Panel Report

**Baw Baw Planning Scheme Amendment C131bawb
Trafalgar, Neerim South and Longwarry Design and
Development Overlays**

22 June 2020

Figure 6 Key directions of Trafalgar UDF

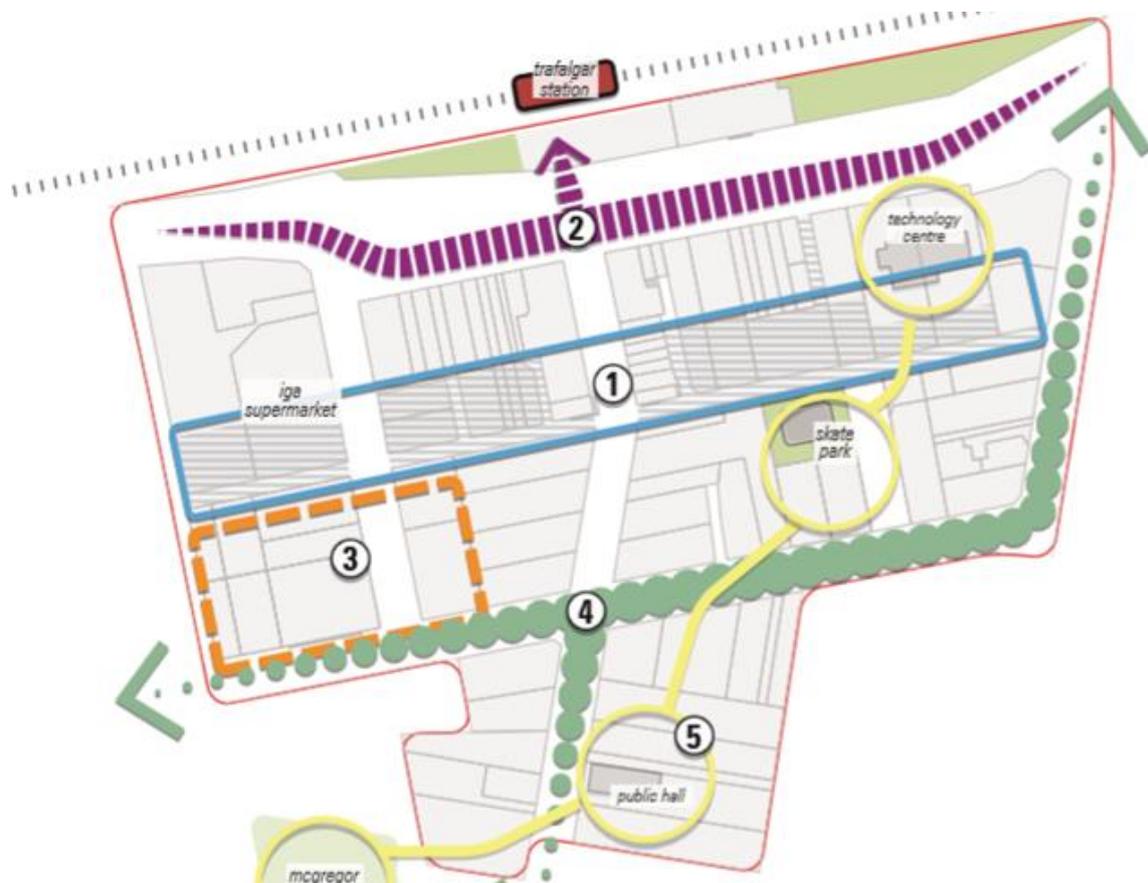
The submissions from Larent Nominees Pty Ltd (submission 5) and Mr Gerard Avon (submission 4) related to the Criterion Hotel site at 85 Princes Highway (refer Figure 7). The submissions raised concerns about the Trafalgar UDF proposing the closure of access to the carpark to the rear of the Hotel and its bottleshop access points from Contingent Street/Depot Lane. It considered that this would detrimentally impact the function, safety of drivers and pedestrians, delivery and rubbish removal access and the commercial viability of the bottle shop and other businesses fronting Contingent Street, which rely on the access through the adjacent carpark area. The submission sought retention of existing carpark access arrangements.

Council submitted that DDO3 did not propose the closure of the carpark or its access points from Contingent Street, rather this was a direction of the Trafalgar UDF intended to create a stronger built form along Contingent Street. It indicated that the broader directions for the Depot Lane carpark (including IGA carpark) were to be the subject of a future Masterplan process to achieve greater activation and functionality of that area. In the interim, Council indicated that development proposals including those proposing changes to access to the carpark would include a traffic engineering assessment to resolve any potential traffic conflict issues.

Figure 8 DDO10 Neerim - Map 1 Precinct and Building Height Plan

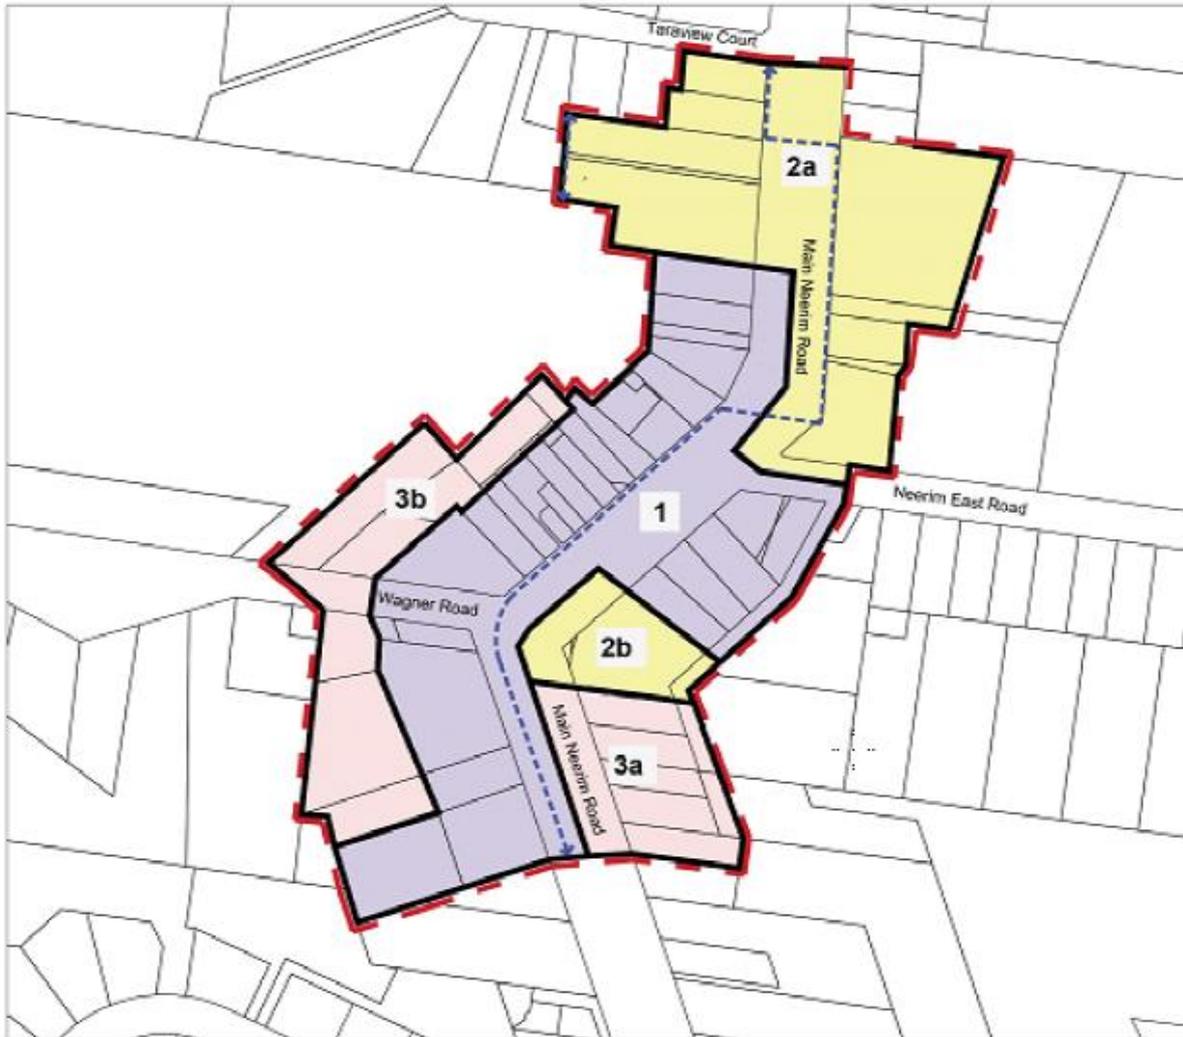
Council further post-exhibition changes to amend Map 1 to remove all pedestrian connections and the precinct colours in Map 1 to avoid conferring land use directions.

While Map 1 does not differentiate different preferred heights across the precincts, the design requirements do refer to different precinct outcomes so the map still has some function. The Panel supports Council's post-exhibition changes to remove the precinct colours included in Map 1 to avoid the inference of land use directions given the colours used in DDO3 in particular.

- **Amend 'Map 1 Precinct and Building Height Plan' to:**
 - **remove the 'Key Pedestrian Connections' linework and legend**
 - **remove the precinct colours.**
- **Amend 'Map 2 Building Setbacks and Access Plan' to:**
 - **delete the accessway and associated landscape setback linework from 7 Wagner Road, 65-81, 85-87, 89 and 91-109 Main Neerim Road.**
 - **include the 'Key Pedestrian Connections' linework and legend from Map 1.**

Figure 9 DDO10 Neerim South - Map 2 Building Setbacks and Access Plan

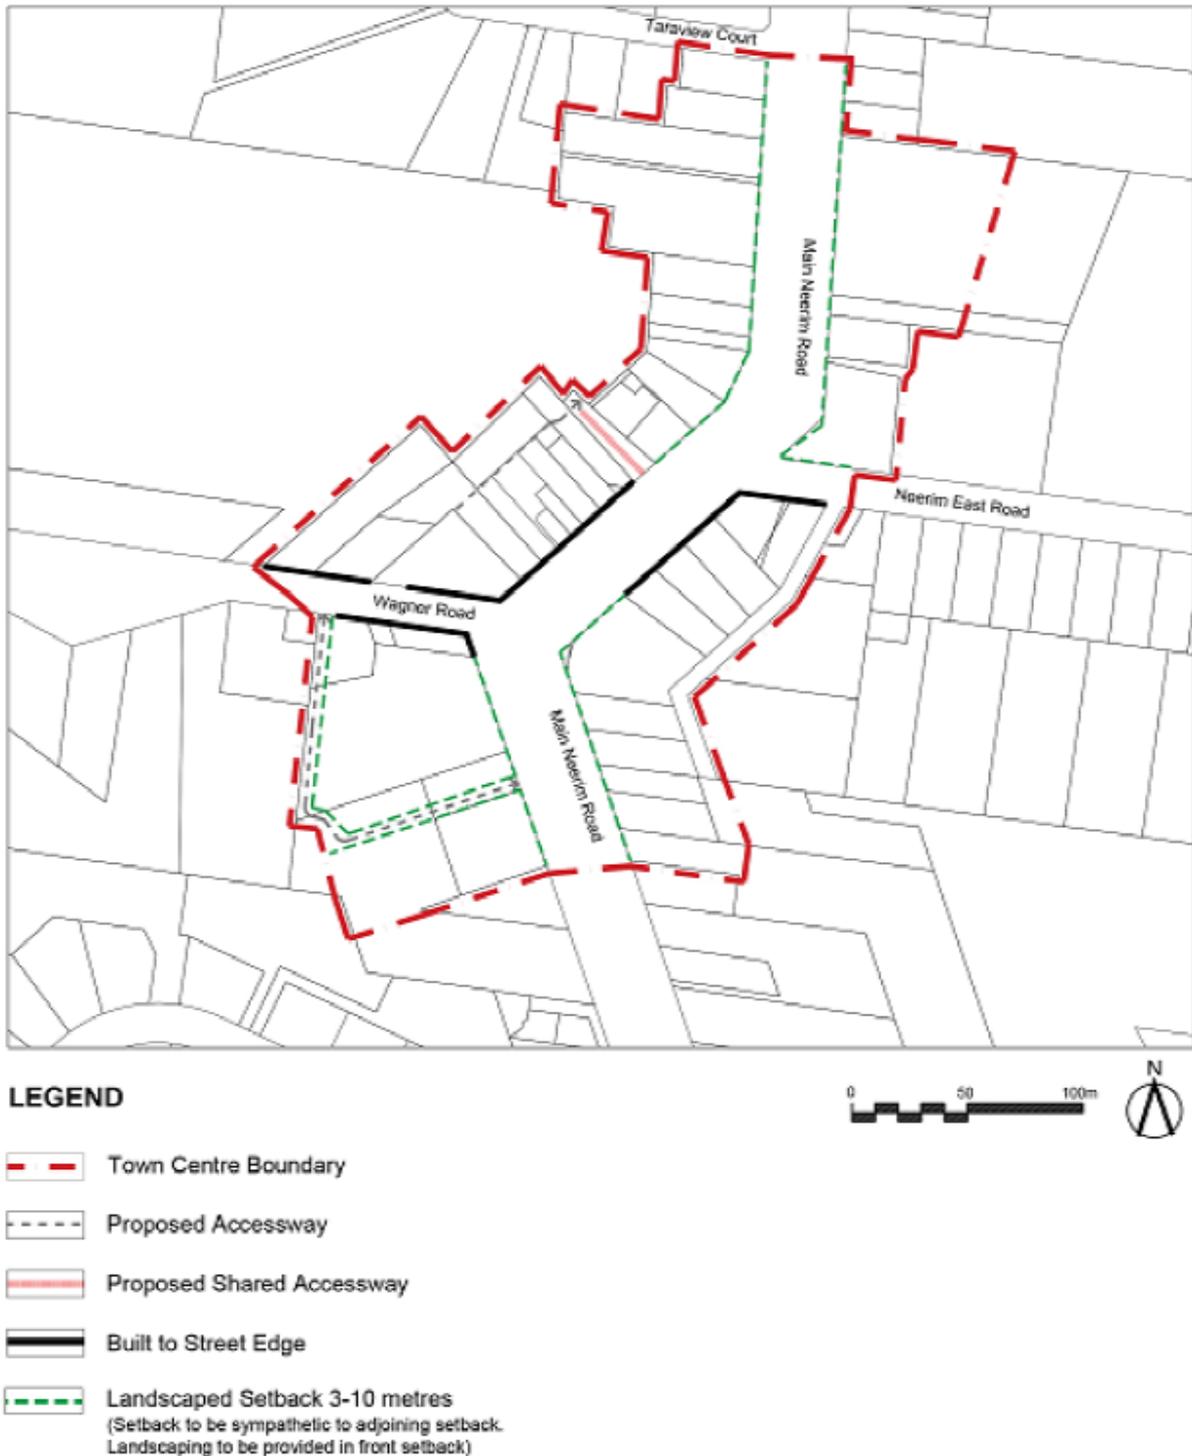
Kerry and Jason Rogan (submission 1) while generally supporting the Neerim South Urban Design Framework raised concern over the identification of a proposed accessway through part of their property at 7 Wagner Road (refer Figure 10). Their concerns related to the impact on such a footpath/roadway on their dwelling and loss of use of their deck resulting in associated privacy and amenity impacts, property value and the loss of fruit trees, fencing and a wood shed. The submission sought removal of the accessway direction and notation and confirmation that Council would not seek to compulsorily acquire the proposed accessway land.

Council's submission agreed with the concerns of submitter 1 and proposed further changes to amend Map 2 within DDO10 to remove the identified accessway and the landscape setback linework from 7 Wagner Street and adjoining properties to the south (65-81, 85-87, 89 and 91-109 Main Neerim Road). Appendix 1 of Council's Part B submission contained correspondence to submitter 1 confirming this approach.

- Map 2 in DDO10 should be amended to remove the accessway and associated landscape setback delineated on 7 Wagner Road, 65-81, 85-87, 89 and 91-109 Main Neerim Road.
- The Neerim South UDF is appropriate to be included as a background document in the Baw Baw Planning Scheme.

Figure 11 DDO11 Longwarry - Map 1 Precinct and Building Height Plan

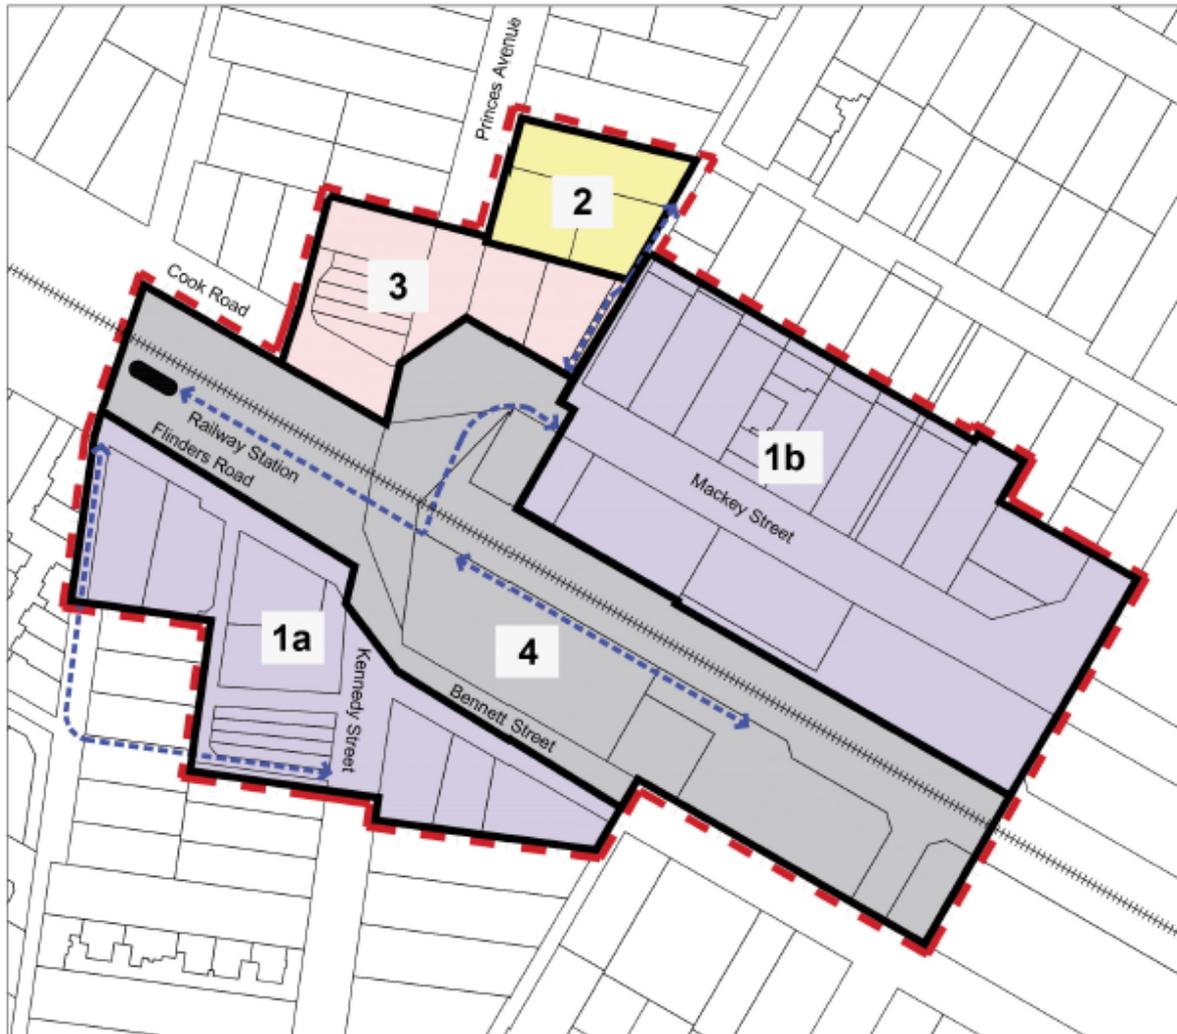
AGT Developments Pty Ltd (submission 3) sought changes to Map 1 of DDO11 to remove the 'Community/Education uses' designation from 2 Princes Avenue, Longwarry (refer Figure 13) so as to retain its current Commercial 1 Zone opportunities. Mr McGuire for AGT Developments identified that the site was currently vacant and adjoins a kindergarten to the east which abuts Ford Place.

Council submitted that for DDO11 there was now little value in including Map 1 as the preferred building heights were the same for all areas. It identified amended wording for DDO11 height requirements that removed reference to that Map. Council also proposed to remove pedestrian connections from all DDOs.

The Panel supports Council’s post exhibition changes to remove the current Map 1 from DDO11 because it:
